INDIANA DEPARTMENT OF TRANSPORTATION

STANDARDS COMMITTEE MEETING MINUTES

RE: Minutes for the July 20, 2006 Standards Committee Meeting

STANDARD DRAWING NO. E 205-TECD-01

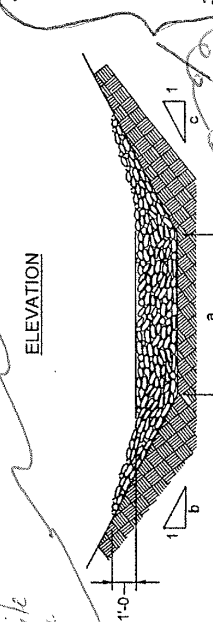
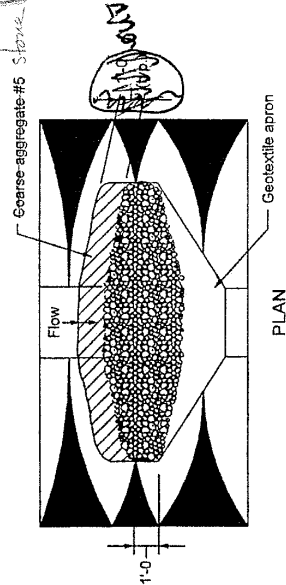
① Riprap ditch check dams shall be spaced such that the top of the downstream check dam is at the same elevation as the toe of the adjacent upstream check dam.

INDIANA DEPARTMENT OF TRANSPORTATION	
WORKSITE SPEED LIMIT SIGN ASSEMBLY	
SEPTEMBER 2002	
STANDARD DRAWING NO. 801-TCDV-10	
	RICHARD L. VANCELEAVE DESIGN STANDARDS ENGINEER DATE
	RICHARD K. SMULZER CHIEF HIGHWAY ENGINEER DATE

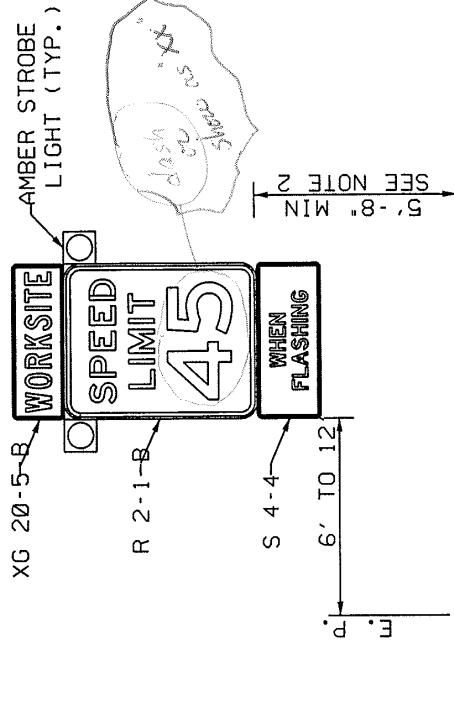
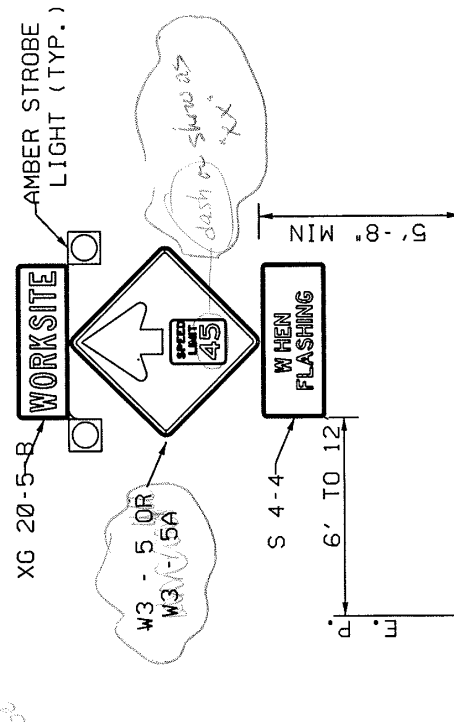
1. Replace the R-15b-B (Reduced Speed 45 Ahead) with either W3-5 or W3-5A (symbolic or text diamond shaped 45 MPH Ahead, 48" x 48")
2. Add the S4-4 (When Flashing) sign to the "advance warning" sign, same as the worksite assembly sign.
3. Reduce the minimum height to 4' from edge of pavement to the bottom of the "When Flashing" plaque.
4. There is a duplication - remove the second "Min.".

Action: Passed as developed at meeting
Effective - January 2007 Letting
2008 Standards Edition
